AGENDA ITEM 4D

**Waiver, Revised Preliminary Plat, Final Plat,
and Public Hearing on Planned Unit
Development Site Plan and Conditional
Use Permit – Woodhouse Place – LB
Southwest Investments, LLC**

RECOMMENDATION REPORT

CASE NUMBER: PSPP-17-0001
PSFP-17-0001
PPUD-17-0001
PCUP-17-0001

REVISED PRELIMINARY PLAT DRAINAGE MAP/PCSMP

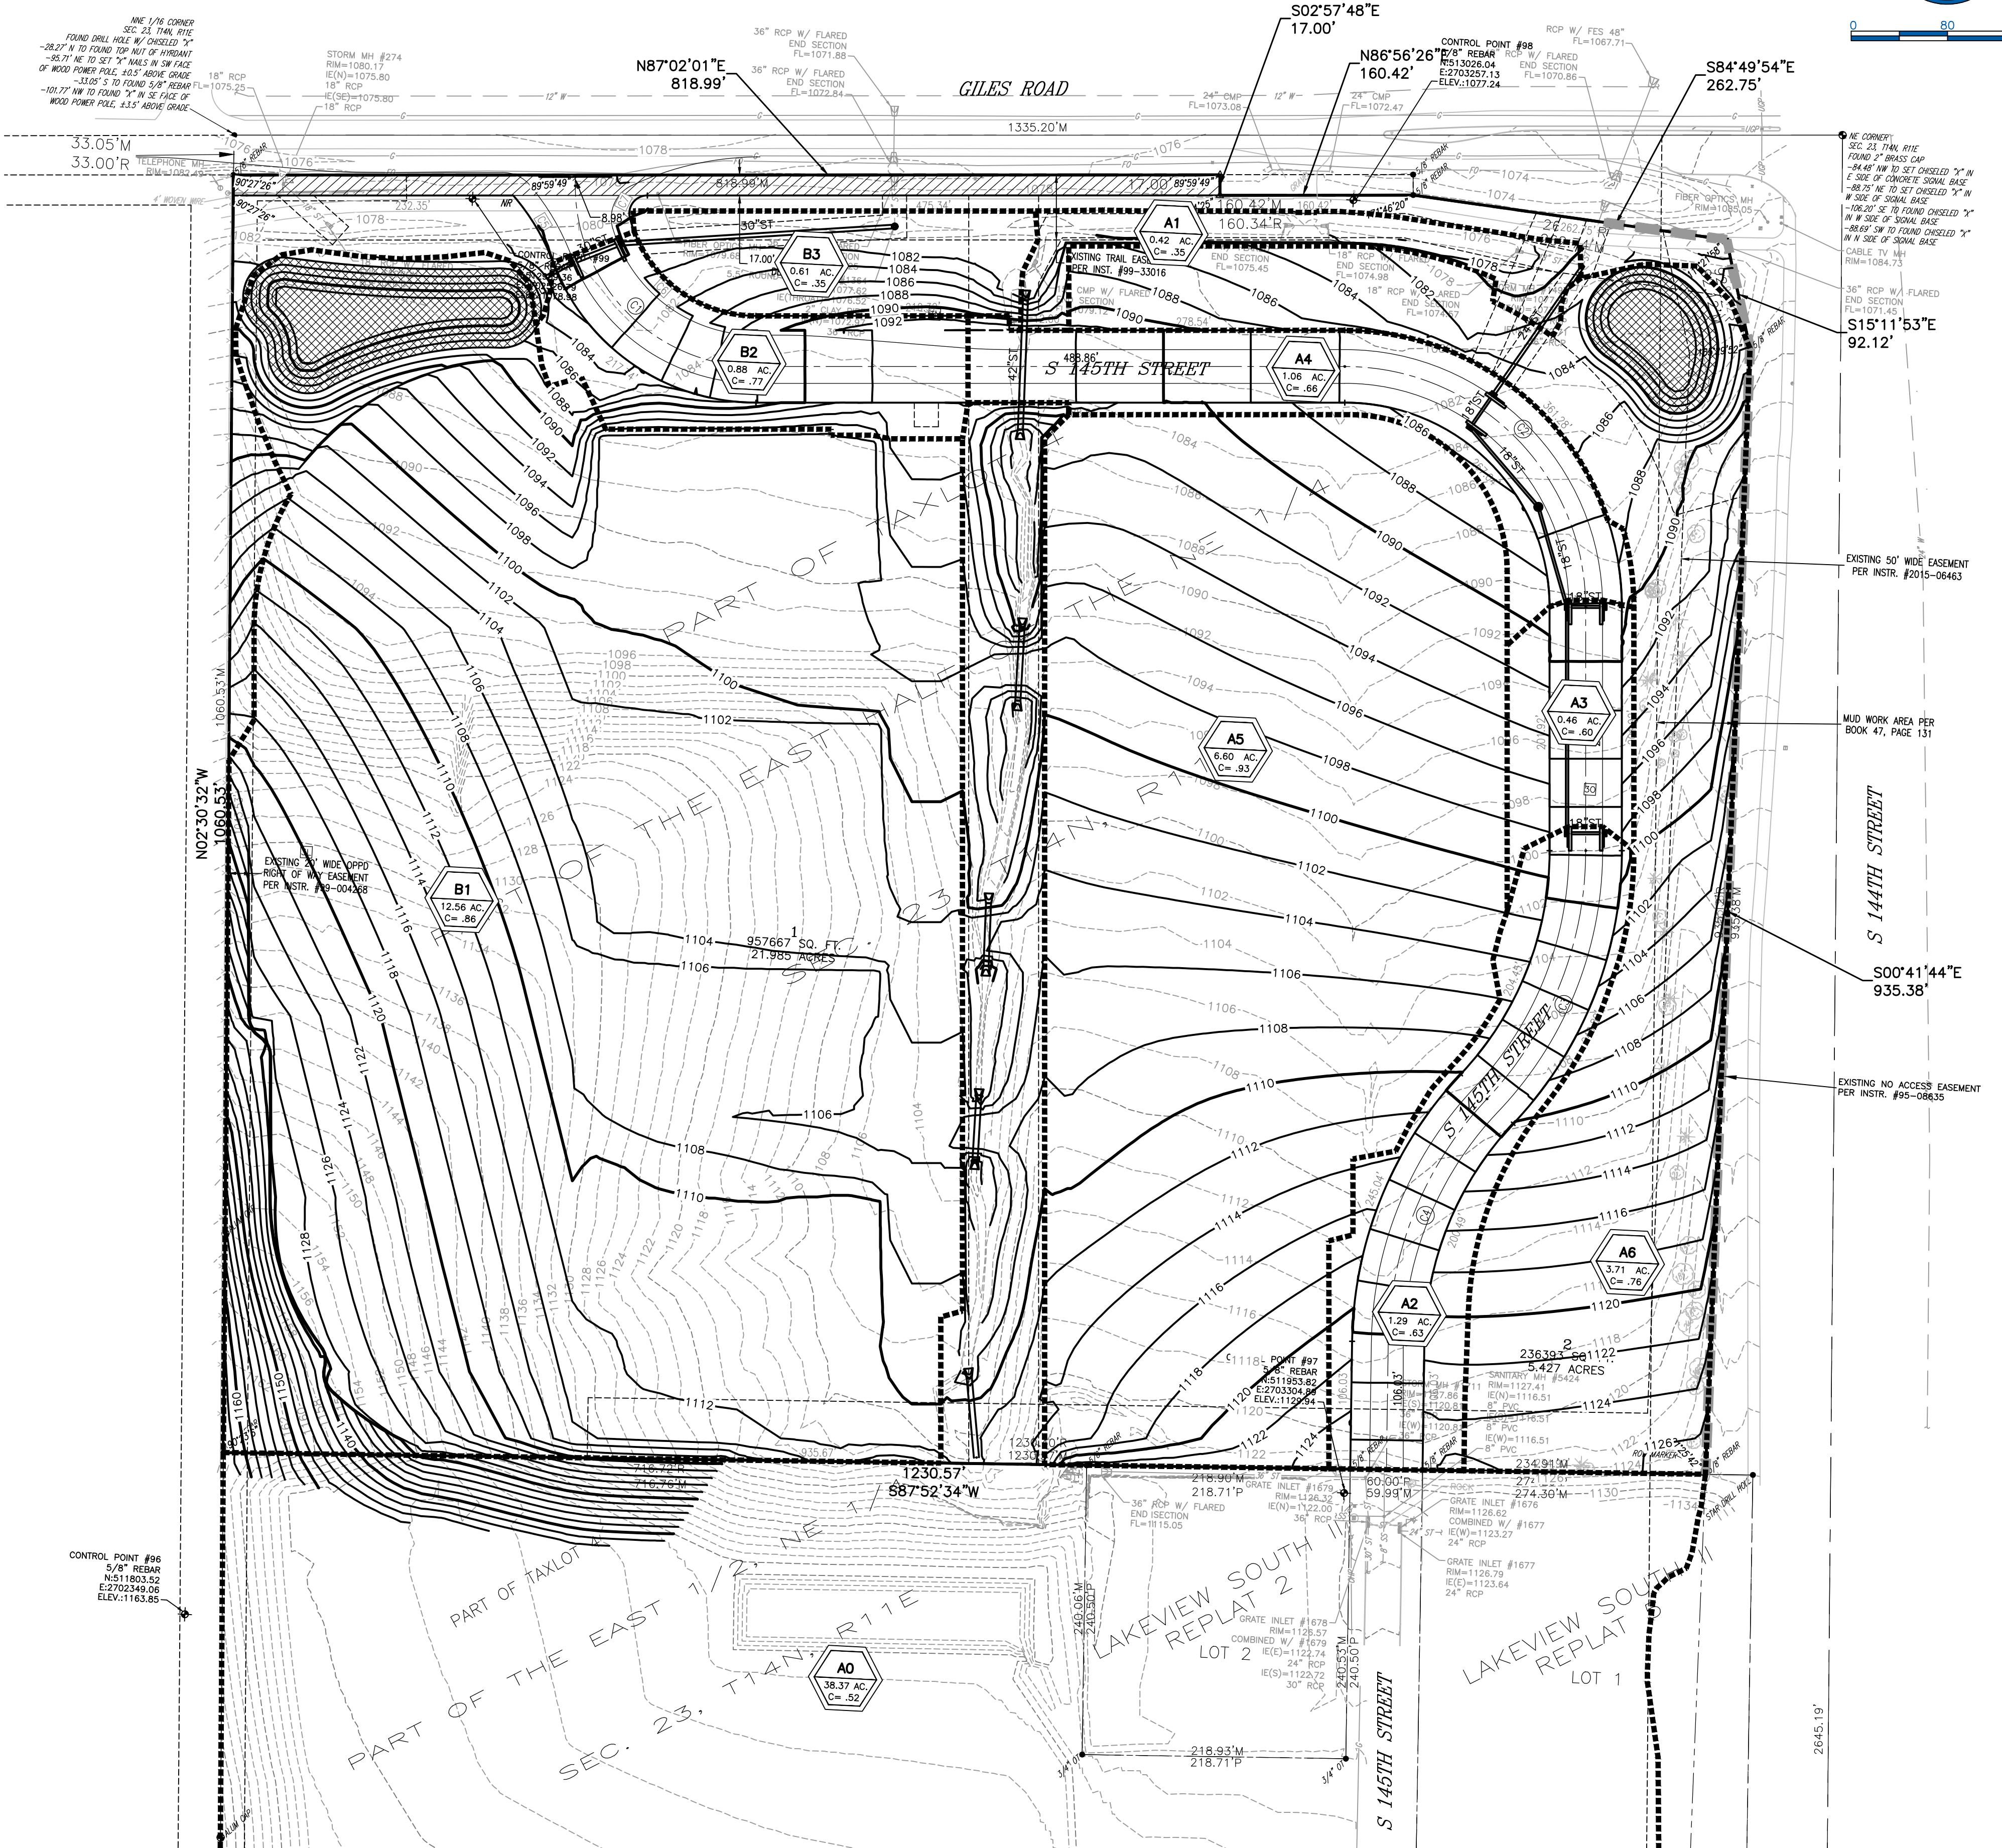
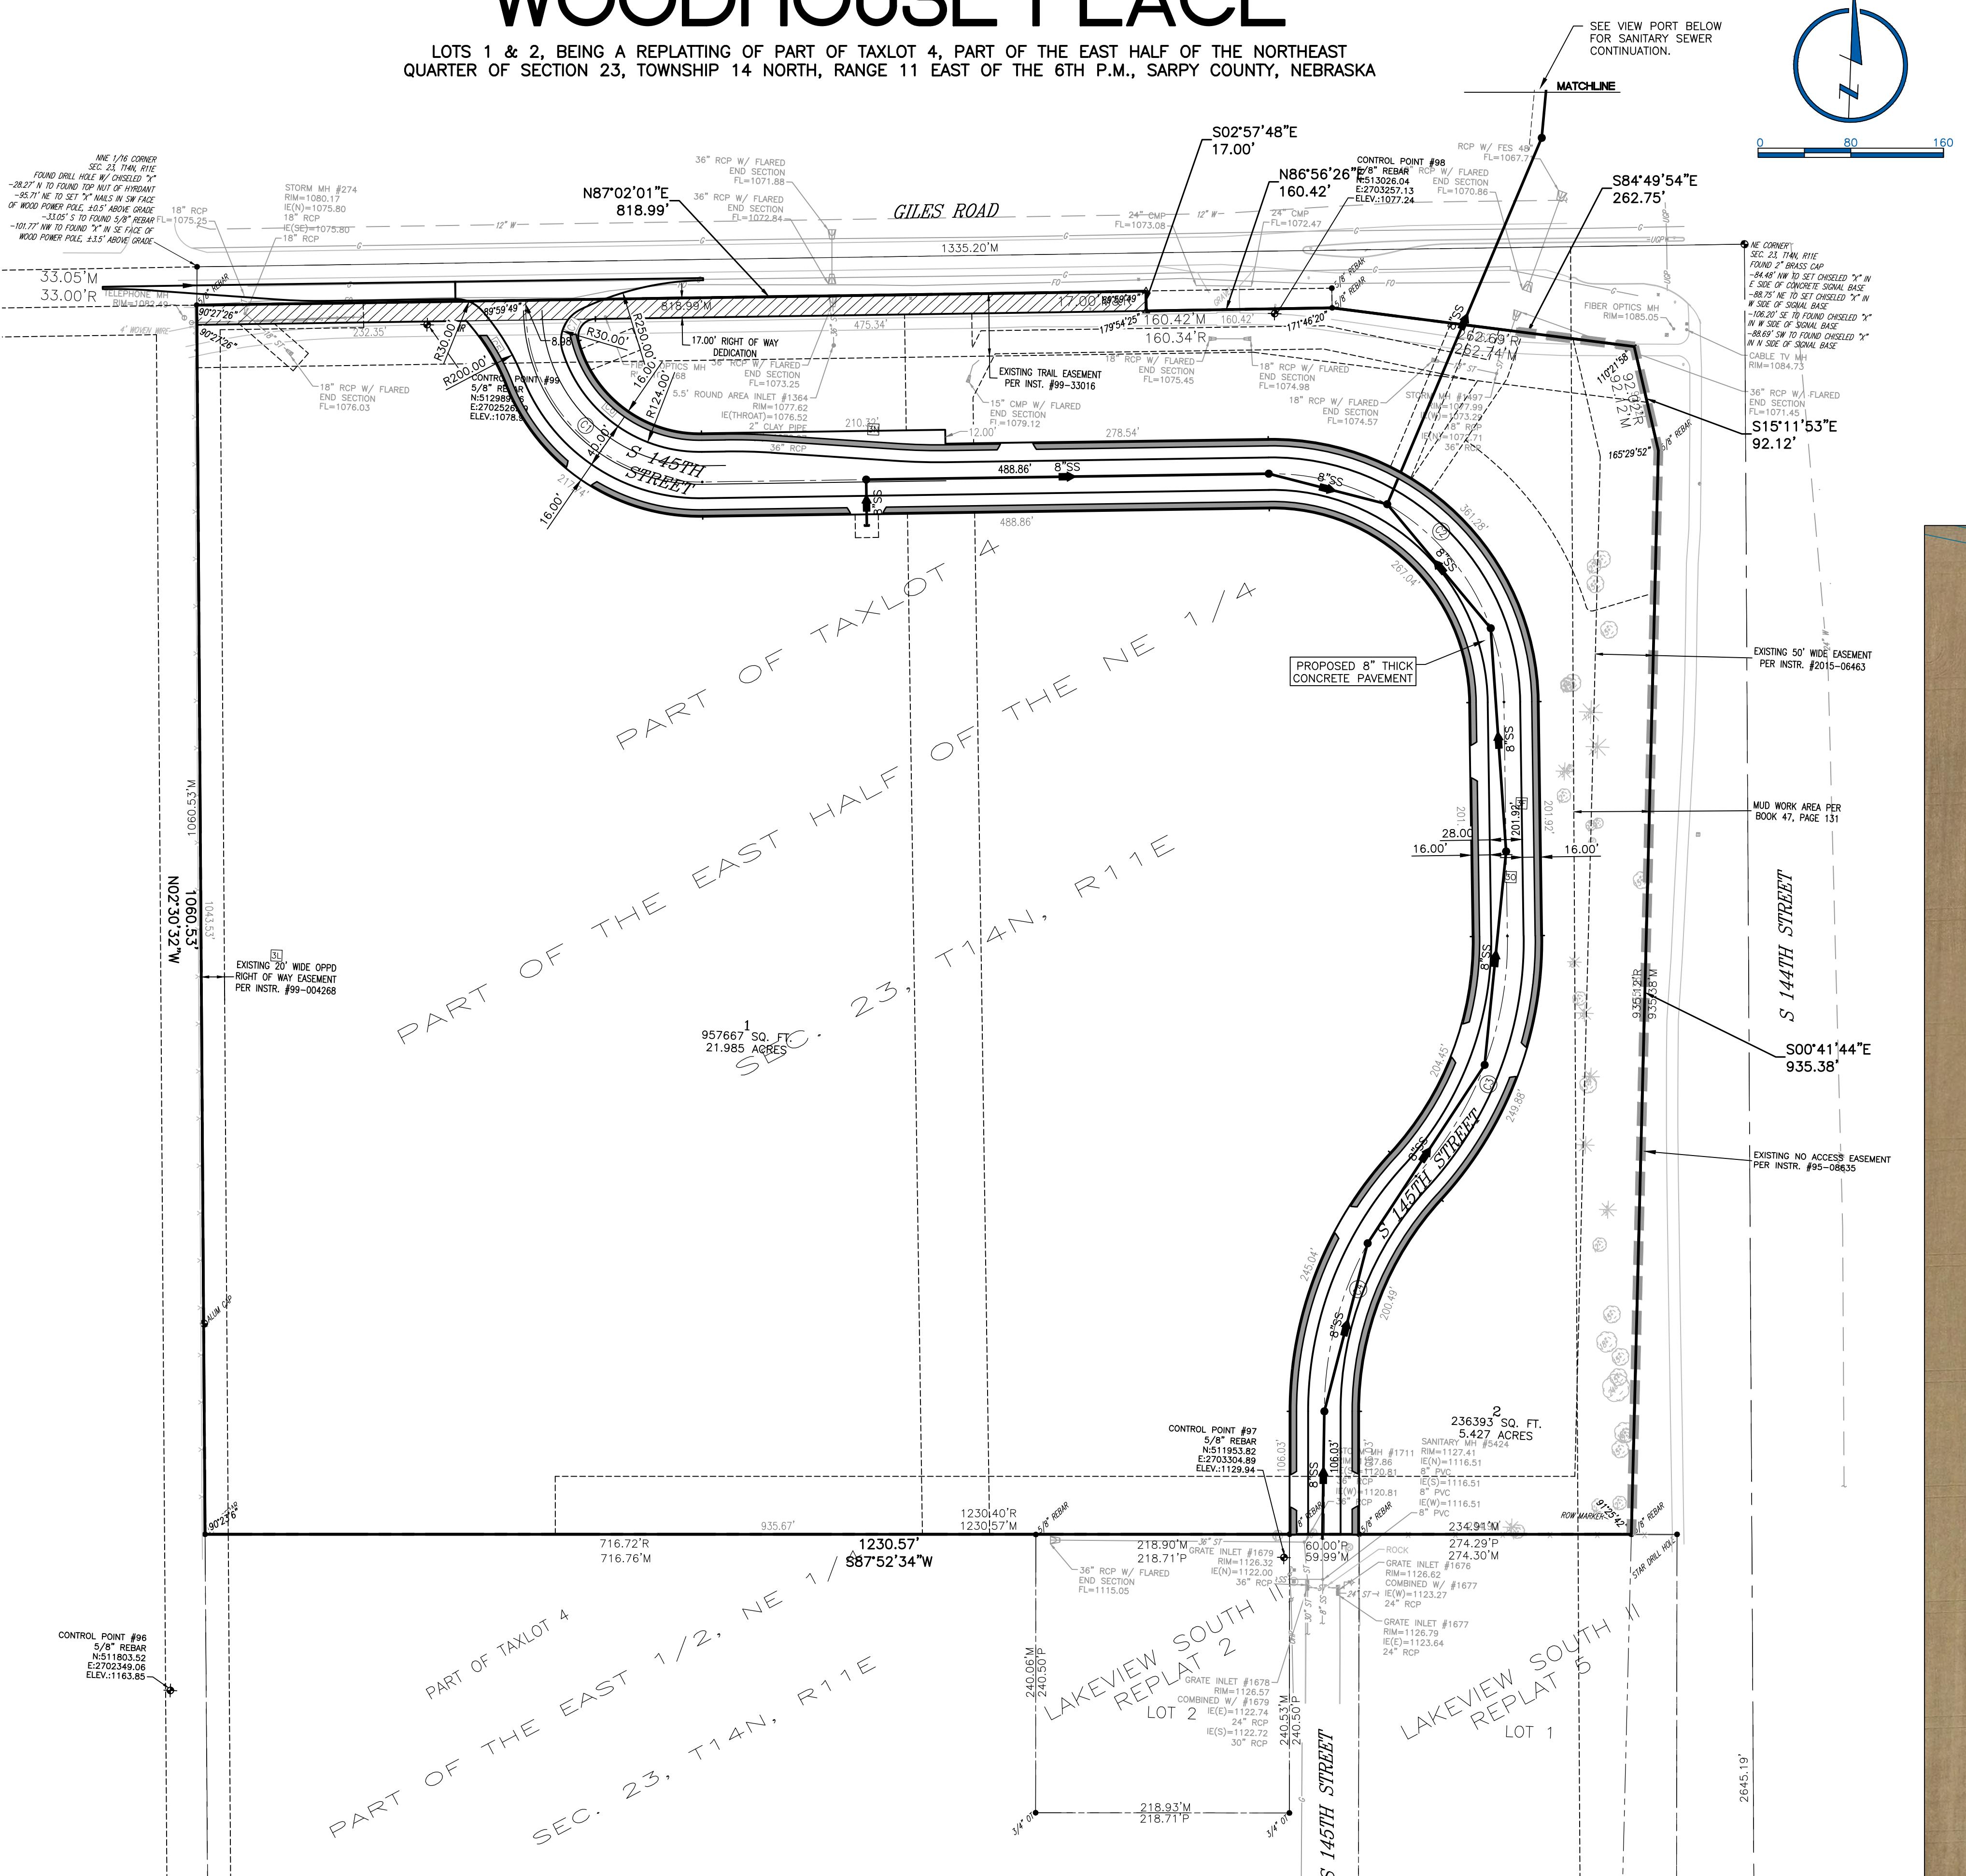
- a. **Comment:** The drainage study needs to address no increase in peak runoffs for 2-year frequency storm events per the Papillion Creek Watershed Partnership policies. This includes drainage areas for proposed public streets.

- b. **Comment:** The study needs to identify the Giles Road culvert capacity limitations. The drainage map and capacity calculations to these existing culverts need to be obtained from Sarpy County Public Works and included in the study as an appendix.

- c. **Comment:** Provisions for $\frac{1}{2}$ -inch water quality treatment from public street pavement will need to be addressed. This might include a diversion of low flows from the public storm sewers into the water quality basins or some other solution.

- d. **Comment:** Provide runoff calculations and sizing calculations for the proposed 42- inch culvert under 145th Street that includes the off-site drainage area from the south that drains into this culvert. The flows will need to be within the capacity limitations of the existing Giles Road culverts. If the intent is to rely on off-site detention to the south in the Heimes development, then there will be a need to demonstrate this coordination.

- e. **Comment:** It is recommended to consider the connection of the proposed storm sewer in 145" Street to the existing storm sewer in 145th Street. This could reduce culvert size issues in the drainage ditch through the center of the site. A coordination meeting with Thompson, Dreessen and Dorner (TD2) (consultants for Heimes) is recommended to explore this option.

- f. **Comment:** In the first table under the Water Quality Treatment section the basins to Pond A should be A1 through A5 unless an alternative method is proposed.

g. **Comment:** Water quality treatment for area B1 needs to be provided.

h. **Comment:** In the second table under the Water Quality Treatment section the Pond A outlet flow for 2-year storms is too high and must be less than the pre- development conditions.

i. **Comment:** In Section C-Hydraflow Analysis it indicates no net increase for each storm event which does not seem to be the case from the calculations presented. Clarify as required.

Response: The drainage study has been revised to illustrate the restriction of peak flow during the 2-year frequency storm. Although runoff routed to public streets bypasses the water quality ponds, the ponds were oversized to provide excess storage which allows for the overall flow offsite to be restricted to a point below the historical peak flow.

Response: The revised drainage study includes several pages from the Giles Road improvements drainage study that indicate that the Woodhouse Place project is restricting peak flows below the existing culvert capacity.

Response: Based on discussion with the City Engineer John Kottmann the $\frac{1}{2}$ -inch water quality treatment from public right-of-way may bypass the water quality ponds, if the ponds are shown to treat additional volume equal to the required right-of-way volume. As discussed, this is similar to how other jurisdictions handle the water quality for public right-of-way. The water quality ponds have been oversized to provide sufficient water quality treatment volumes for the entire disturbed area. This includes drainage areas that bypass the ponds.

Response: Runoff and sizing calculations for the culvert under 145th Street are included in the revised drainage study. The Woodhouse Place project will not rely on any offsite detention from the properties situated to the south, aside from what is ordinarily required. The Woodhouse Place project will limit the peak discharge during the 50-year frequency storm, so that when this flow is combined with flows offsite, it is below the capacity of the existing culvert under Giles Road. During design, we will coordinate with the owner of the adjacent properties to discuss the potential for detention to reduce the internal culvert sizes.

Response: This option was presented to the United States Army Corps of Engineers (USACE) on November 30, 2016. The USACE determined that diverting this flow into 145th Street storm sewer would be a full impact to the jurisdictional waterway, and that they would likely be unsupportive of this option. During final design, LRA will coordinate with the adjacent property owners to discuss potential options for detention and low flow diversions to the waterway.

Response: Agreed. The table has been modified to identify the drainage areas correctly.

Response: The water quality ponds have been oversized to provide sufficient water quality treatment volumes for the entire disturbed area. This includes drainage areas that bypass the ponds.

Response: The drainage study has been revised to illustrate the restriction of peak flow during the 2-year frequency storm.

Response: Agreed. The drainage study has been revised to clarify that there is a no-net increase for the 2-year storm.
